NOTICE UNDER SECTION 96 (1) CHAPTER IX OF THE BOMBAY  
DISTRICT MUNICIPAL ACT III OF 1901 AS MODIFIED  
UPTO THE 1st MARCH 1915.Karachi, 26/4/1932

PLAN SHOWING PROPOSED BUILDING ON  
PLOT NO 66 SHEET NO K.5  
LYAREE QUARTER  
SCALE 8 FT = 1 INCH

PLAN NO 104 OF 1932

Case No. P/C 208 of 1932.Applicant's Name Bali ind F atah indArchitect's Name A. S. S. S. S.Plot No 66 Sheet No. K-5, byani Quarter

DETAIL OF R.C. BEAM AT H.

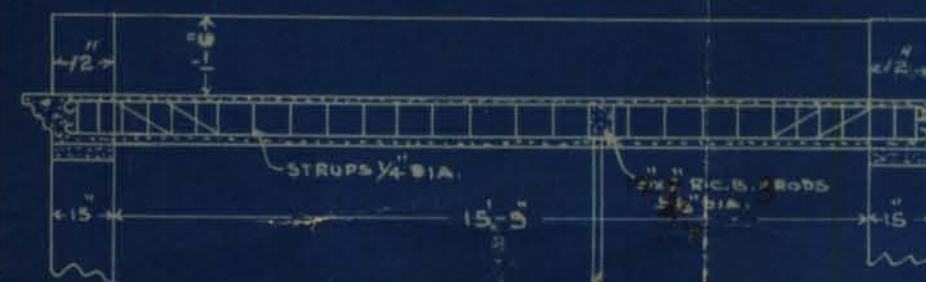
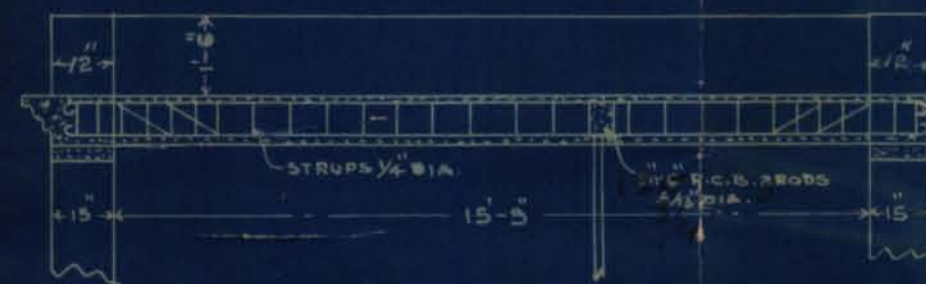
- (1) 2" x 7" R.C. beam are inadequate. They should be changed to 7" x 9" with 5 1/2" dia rods, 4" x 6" in mesh
- (2) 1/2" x 7" 4 rods 1" dia.
- (3) Applicant must prove ownership of the plot.
- (4) It is suggested that the width of internal open air space be proposed 10' instead of 8' so as to allow of an upper storey at future date.
- (5) Set back must be more complete widths of streets must be written down & the height of adjoining buildings also.
- (6) Passage to be 8'.
- (7) Window be provided on wall between passage & room be left 7' 6"
- (8)
- (9)

- 1) 12" x 7" R.C.C. Beams are inadequate. They should be changed to 15" x 8" with 1" diam rods. 4 rods 1" diam.
- 2) Sweepers passage to be proposed 10' wide instead of 3'.
- 3) Applicant must have ownership of the plot.
- 4) It is suggested that the width of internal open air space be proposed 10' instead of 8' so as to allow for an upper story at a future date.

(1) Calculations are attached showing  
size and reinforcement. The weight per sq ft  
is taken 100 per sq. foot. viz lbs 50 for  
live load and lbs 44 for slab.

SITE PLAN

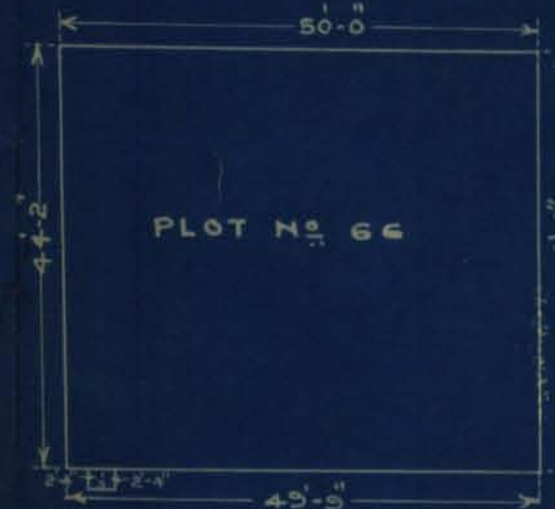
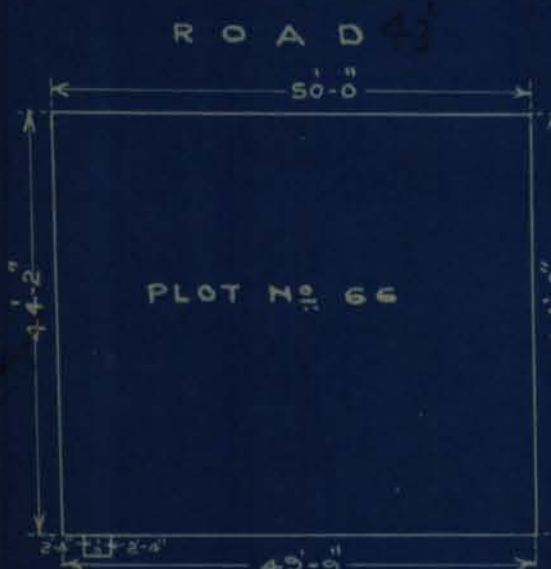
(4) 1) Site plan must be more complete. Widths of streets must be written down and the heights of the adjoining plots also.

(4) Site plan has been completed.
